# Access Compliance Report

## Public Rights-of-Way

Intersection ID: 44446	Main Street: REAMES_RD	Cross Street: PRESTBURY_BV	Location: NW
ADA ID: 30FA5752CABD	Ramp Type: PerpDiag	Initial Pass/Fail: Fail	Overall Compliance: No
		Severity Score: 10

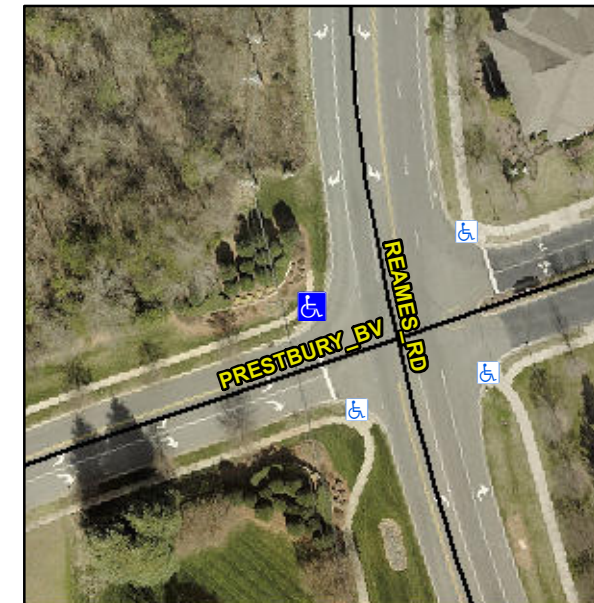
**Not Found, R304.5.1, R304.5.3**

Compliance	Description	Data	Compliance	Description	Data
N/A	Ramp Length (in)	71.5	Yes	Ramp Slope (%)	5.4
No	Ramp Width (in)	45.0	No	Ramp XSlope (%)	2.3
N/A	Flare Type LT	N/A	N/A	Flare Type RT	N/A
N/A	Flare Slope LT (%)	N/A	N/A	Flare Slope RT (%)	N/A
N/A	Flare Traversable LT?	N/A	N/A	Flare Traversable RT?	N/A
N/A	Landing Length (in)	N/A	N/A	DWS Provided?	N/A
N/A	Landing Width (in)	N/A	N/A	DWS Contrast?	N/A
N/A	Landing Slope (%)	N/A	N/A	DWS Length (in)	N/A
N/A	Landing X Slope (%)	N/A	N/A	DWS Full Width?	N/A
N/A	Landing Curb? (Y/N)	N/A	N/A	DWS Offset (in)	N/A
N/A	Shared Landing?	N/A			
N/A	Gutter Ponding?	N/A	N/A	Gutter Slope (%)	N/A
N/A	Gutter Lip Ht (in)	N/A	N/A	Gutter X Slope (%)	N/A
N/A	Painted X Walk1?	No	N/A	Painted X Walk2?	No
	X Walk 1 Direction	To S		X Walk 2 Direction	To E
N/A	X Walk 1 Width (in)	N/A	N/A	X Walk 2 Width (in)	N/A
	X Walk 1 Slope (%)	0.5		X Walk 2 Slope (%)	0.8
	X Walk 1 X Slope (%)	2.5		X Walk 2 X Slope (%)	0.5

**Remove & Replace Curb Ramp With Two New Directional Ramps or Equivalent.**
